Department of Planning & Community & Economic Development
Planning Division

November 28, 2011

RE: Approval of a demolition permit and conditional use to allow a former convenience store to be demolished and a new gas station, car wash, and convenience store with restaurant tenant space to be constructed at 1101 N. Sherman Avenue (Farooq Shahzad).

1 LANDSCAPE PLAN 11X17
1" = 20'-0"

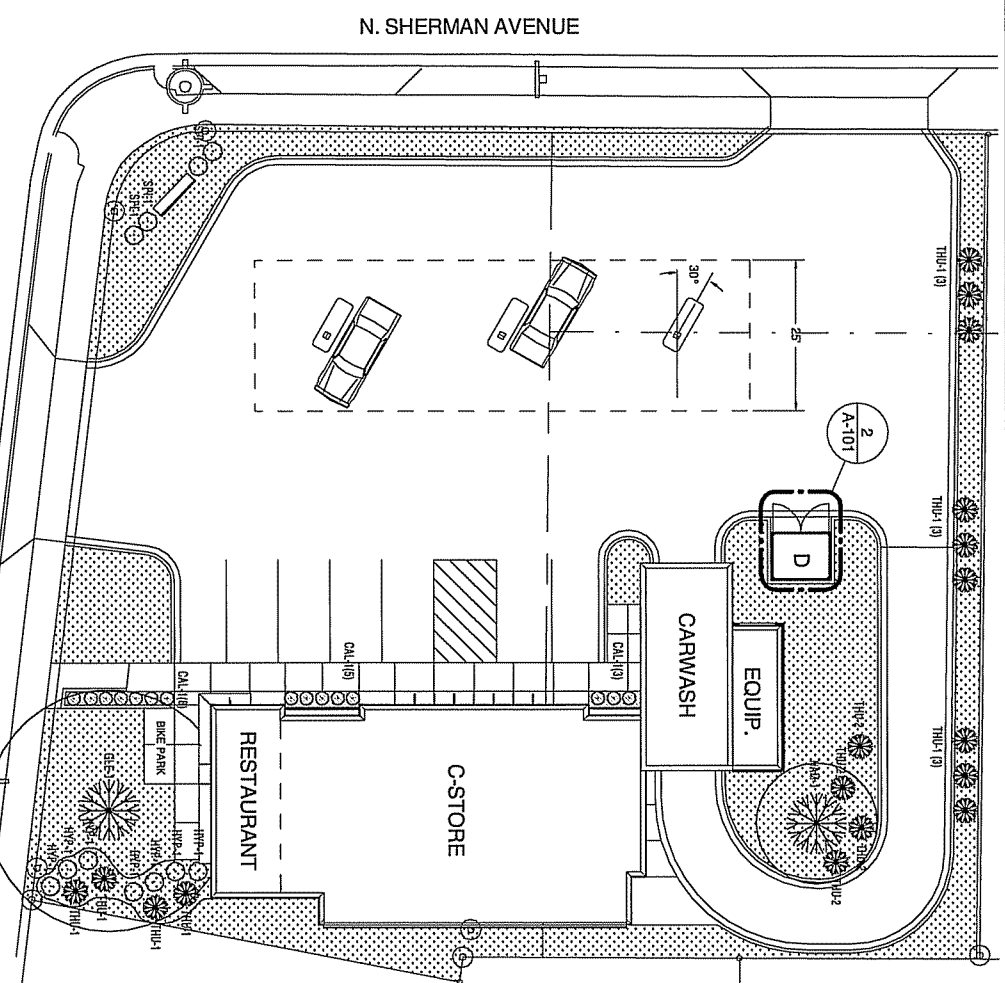
10. The applicant shall indicate the type of City approved bicycle racks to be installed and locations. The bike rack should be located by the entrances to the buildings.

- b.) Show signage at the head of the stalls. Accessible signs shall be a minimum of 60" between the bottom of the sign and the ground.
 - c.) Show the accessible path from the stalls to the buildings. The stalls shall be as near the accessible entrance as possible. Show ramps, curbs, or wheel stops where required.

17. Bike parking shall comply with MGO Section 28.11. Provide 2 bike parking stalls in a safe and convenient location on an impervious surface to be shown on the final plan. The lockable enclosed lockers or racks or equivalent structures in or upon which the bicycle may be locked by the user shall be securely anchored to the ground or building to prevent the lockers or racks from being removed from the location. Note: A bike-parking stall is 2 feet by 6 feet with a 5-foot access area. Structures that require a user-supplied locking device shall be designed to accommodate U-shaped locking devices.

- a.) show the location of any propane sales and exchange cages;
 - b.) show the location of the underground fuel pumps on Sheet C102;
 - c.) show the planting of shrubs and perennials in the strip located between the fuel service area and N. Sherman Avenue sidewalk and the planting of additional shrubs or perennials along the northern property line;
